SUNDRY NOTICES AND REPORTS ON WELLS
Do not use this form for proposals to drill or to re-enter an
abandoned well. Use form 3160-3 (APD) for such proposals.

8. Well Name and No.
H B.11 FEDERAL 3

(Instructions on page 2) ** BLM REVISED **

PROPOSED WELLBORE

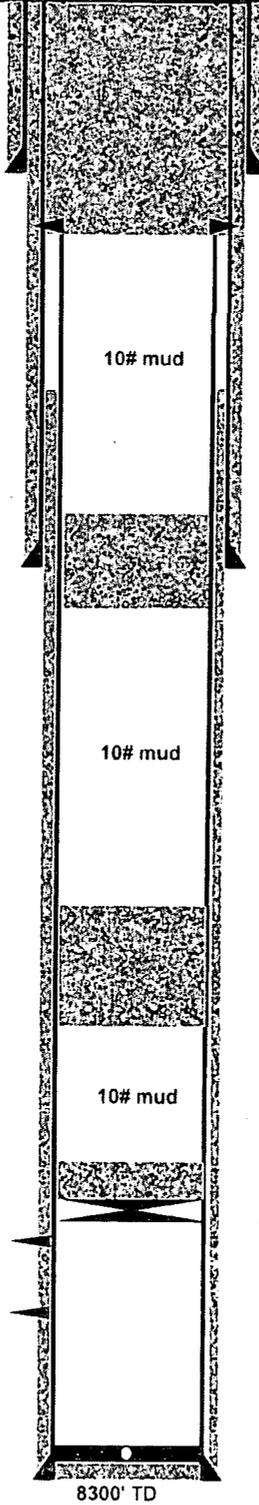
- Proposed: **7760'**
1. Set CIBP @ **7775'**. Tag, Circ 10# salt gel.
 2. Spot 25 sx Cl H from 7775'-7575'.
 (Perfs at @ 7810')
- Leak test CIBP**

- MIRU P&A unit. TOOH rod string and 2-7/8" production tubing from ~8050'.
- Set CIBP @ ~~7775'~~ Tag. Circ 10# salt gel. Spot 25 sx CI H from ~~7775'-7575'~~ (Perfs at @ 7810') 7760' - 7575' Leak Test CIBP
- Spot 50 sx CI C from 6820'-6320'. (T. Bone Spring @ 6768')
- Spot 45 sx CI C from 3320'-2875'. WOC & tag. (T. Delaware/B. Salt @ 3080'; Shoe @ 2940')
- Perf @ 650'. Sqz 170 sx CI C from 650' to surface. (T. Salt @ 577'; Shoe @ 385')
- Cut wellhead off 3' BGL, set dry hole marker.
